Seagate Technology

9/11/98

Subject: Revision 5 of the Proposal for the Fast 80 Specifications in the SPI-3 Standard

Revision 5 is a delta change on top of Revision 4. It has changed some cases of assertion which in double transition mode should be transition (i.e. assertion or negation). In the course of looking for these cases some additional editorial changes were made. No technical changes were made in Revision 5. Since Revision 4 had not yet been reviewed in a meeting the change bars in Revision 5 include the changes made in Revision 4 which were:

Figure 4 - Fast-80 **Double Transition** System setup and hold timings (all times in ns)

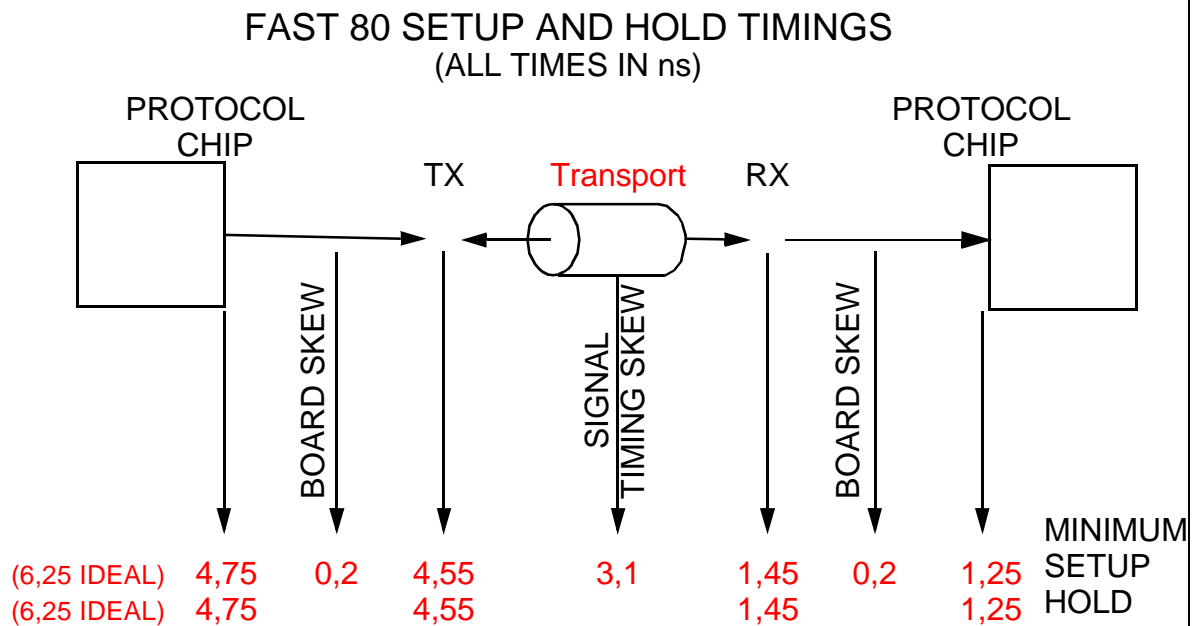
~~INT T/R indicates integrated protocol and transceiver chip~~

~~Board skew includes the separate transceiver and trace skew~~

Signal timing skew includes cable skew and signal distortion skew

Distortion skew includes ISI (intersymbol interference) and differences in signal crossing time through the receiver detection range
